UNITED STATES PATENT AND TRADEMARK OFFICE

APPLICATION NO.	FILING DATE	FIRST NAMED INVENTOR	ATTORNEY DOCKET NO.	CONFIRMATION NO.
10/061,570	02/01/2002	John Keightley	024931-147	9660
7590	08/03/2004			
Robert E. Krebs Thelen Reid & Priest LLP P O Box 640640 San Jose, CA 95164-0640				
			EXAMINER STAFIRA, MICHAEL PATRICK	
			ART UNIT 2877	PAPER NUMBER

DETAILED ACTION

Claim 1

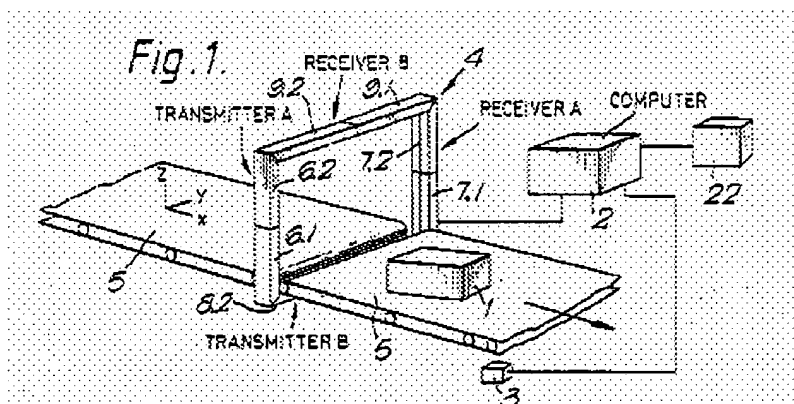
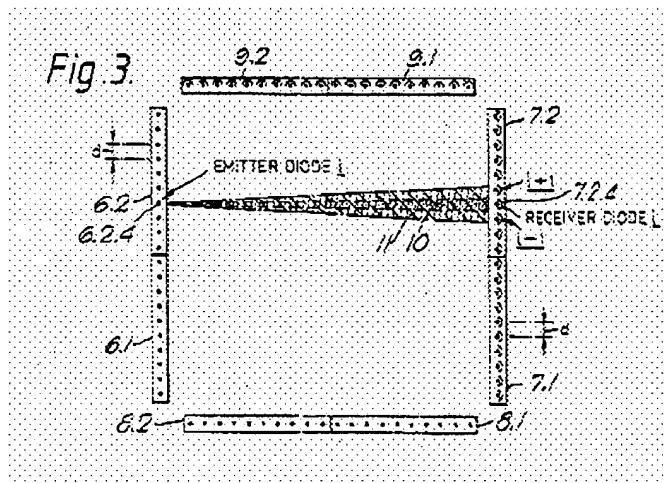
Claesson et al. ('029) discloses a light source unit comprised of an emitter module that emits a laser sheet (Fig. 3, Ref. 6.2); a detector array comprised of a detector module (Fig. 3, Ref. 7.2), wherein said emitter module and said detector module are aligned (See Fig. 3); and a data processing unit (Fig. 1, Ref. 2); such that an object passing between said light source unit and said detector array (See Fig. 1, Ref. 1) can be measured to an accuracy of at least 4/100ths of an inch (Col. 15, lines 3-5) which is in the range disclosed by Claesson et al. ('029) being +-5 mm.

Claesson et al. ('029) discloses the claimed invention except for disclosing the accuracy can be at 4/100ths of an inch. It would have been obvious to one having ordinary skill in the art at the time the invention was made to combine Claesson et al. ('029) with accuracy since it was well known in the art that having an accuracy of 4/100ths gives the apparatus a suitable detail that is not expensive, therefore lowering the cost of the apparatus.

**Claim 5**

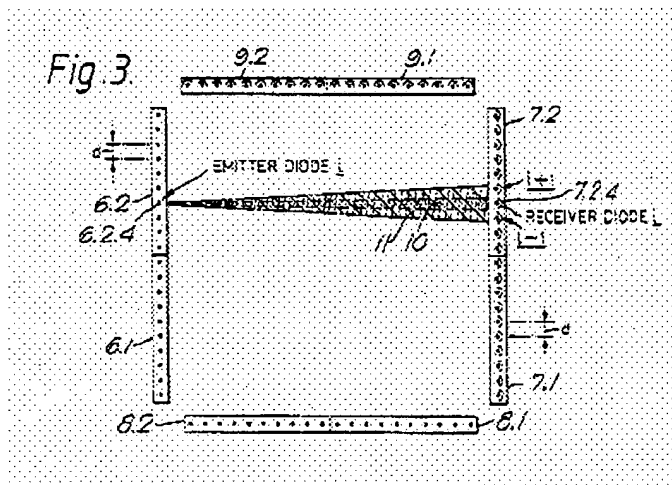
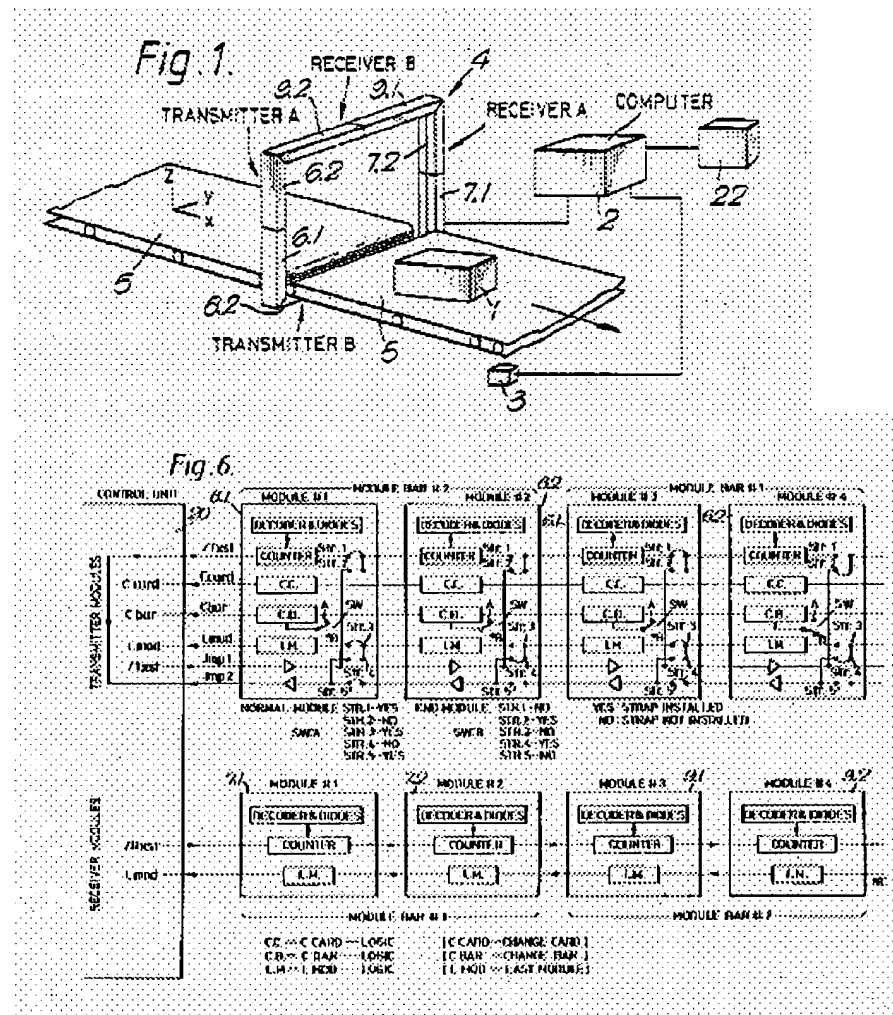
Claesson et al. ('029) discloses a light source unit (Fig. 3, Ref. 6.2) comprised of a plurality of emitter modules (Fig. 3, Ref. 6.2.4) that combine to emit a laser sheet (See Fig. 3); a detector array (Fig. 3, Ref. 7.2) comprised of a plurality of detector modules (Fig. 3, Ref. 7.2.4) wherein each of said plurality of emitter modules and each of said plurality of detector modules are aligned (See Fig. 3); and one or more data processing units (See Fig. 6, Ref. 7.1, 7.2, Etc.); such that an object (Fig. 1, Ref. 1) passing between said light source unit and said detector array can be measured to an accuracy of at least 4/100ths of an inch (Col. 15, lines 3-5).

Claesson et al. ('029) discloses the claimed invention except for disclosing the accuracy can be at 4/100ths of an inch. It would have been obvious to one having ordinary skill in the art at the time the invention was made to combine Claesson et al. ('029) with accuracy since it was well known in the art that having an accuracy of 4/100ths gives the apparatus a suitable detail that is not expensive, therefore lowering the cost of the apparatus.

Claim 9

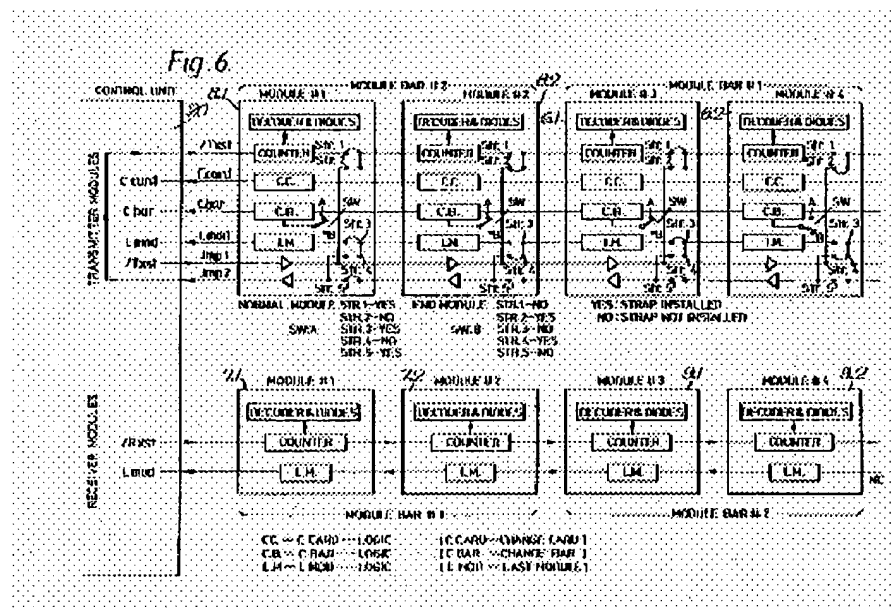
Claesson et al. ('029) further discloses the number of data processing units (Fig. 6, Ref. 7.1, 7.2, etc...) is equal to a fraction of the number of said detector modules such that each data processing unit provides data processing for a number of detector modules located adjacent to one another (See Fig. 6).
